## **Access Compliance Report Public Rights-of-Way** (Curb Ramps)

Main Street: JOHNSON ST **Cross Street: POLK ST** Intersection ID: 10748 Location: S Initial Pass/Fail: Fail **Overall Compliance: No** 22.5 **ADA ID: F9AA2066C36C** Ramp Type: Combination1 **Severity Score:**

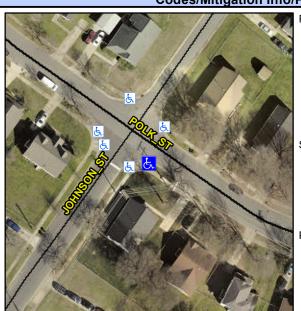
Street 1 Name None Stop Condition-Street 1 **POLK ST** N/A Street 2 Name Stop Condition-Street 2 N/A Possible Solutions: Compliance Description Remove & Replace Entire Ramp. N/A Yes Yes No N/A No Surveyor Notes: N/A **CURB LIP, CURB GAP 1.5"** N/A N/A N/A N/A PROW/ADA: Not Found, R304.5.1, R304.2.2, R304.5.3
